Access Compliance Report

Public Rights-of-Way

(Curb Ramps)

Intersection ID: 28003	Main Street: COMMUNITY HOUSE RD	Cross Street: WILLOW ROCK DR	Location: SW
ADA ID: EB4369A3F657	Ramp Type: BlendTrans2	Initial Pass/Fail: Fail	Overall Compliance: No
Severity Score: 1.25			
Codes/Mitigation Info/Possible Solution		Field Measurements/Component Compliance

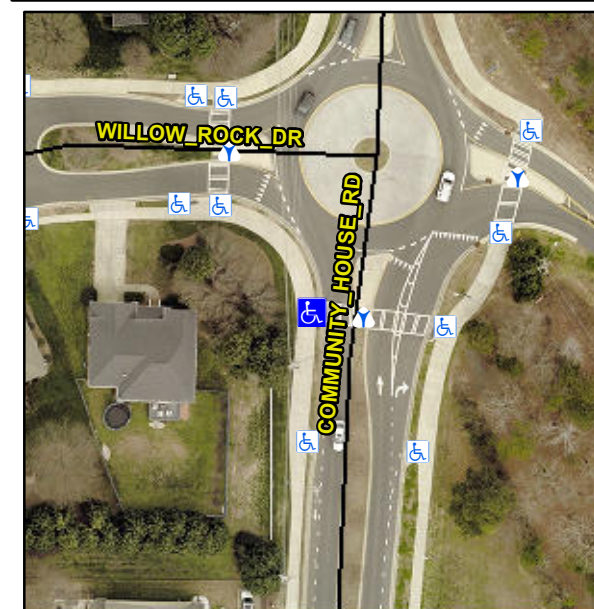
Compliance	Description	Data	Compliance	Description	Data
N/A	Ramp Length (in)	144.0	Yes	BlendTrans Slope (%)	1.6
Yes	Ramp Width (in)	128.0	No	BlendTrans XSlope (%)	2.3
N/A	Flare Type LT	N/A	N/A	Flare Type RT	N/A
N/A	Flare Slope LT (%)	N/A	N/A	Flare Slope RT (%)	N/A
N/A	Flare Traversable LT?	N/A	N/A	Flare Traversable RT?	N/A
N/A	Landing Length (in)	N/A	N/A	DWS Provided?	N/A
N/A	Landing Width (in)	N/A	N/A	DWS Contrast?	N/A
N/A	Landing Slope (%)	N/A	N/A	DWS Length (in)	N/A
N/A	Landing X Slope (%)	N/A	N/A	DWS Full Width?	N/A
N/A	Landing Curb? (Y/N)	N/A	N/A	DWS Offset (in)	N/A
N/A	Shared Landing?	N/A			
N/A	Gutter Ponding?	N/A	N/A	Gutter Slope (%)	N/A
N/A	Gutter Lip Ht (in)	N/A	N/A	Gutter X Slope (%)	N/A
N/A	Painted X Walk1?	Yes	N/A	Painted X Walk2?	N/A
	X Walk 1 Direction	To E		X Walk 2 Direction	N/A
	X Walk 1 Width (in)	129.0		X Walk 2 Width (in)	N/A
	X Walk 1 Slope (%)	4.6		X Walk 2 Slope (%)	N/A
	X Walk 1 X Slope (%)	1.6		X Walk 2 X Slope (%)	N/A

N/A	Ramp inside XWalk1?	Yes	N/A	Ramp inside XWalk2?	N/A
	Road Slope (%)	1.6		Clear Space?	N/A
	Road X Slope (%)	4.6	N/A	Clear Space to XWalk (in)	N/A
N/A	Any Obstructions?	N/A	N/A	Storm Grate/Utility Hazard?	N/A
	Obstruction Type			Storm Grate/Utility Type	
		N/A			N/A
			Yes	Surface Condition? (G/P)	Good
			N/A	Curb Slope (%)	3.9

Remove & Replace Curb Ramp With Two New Directional Ramps or Equivalent.
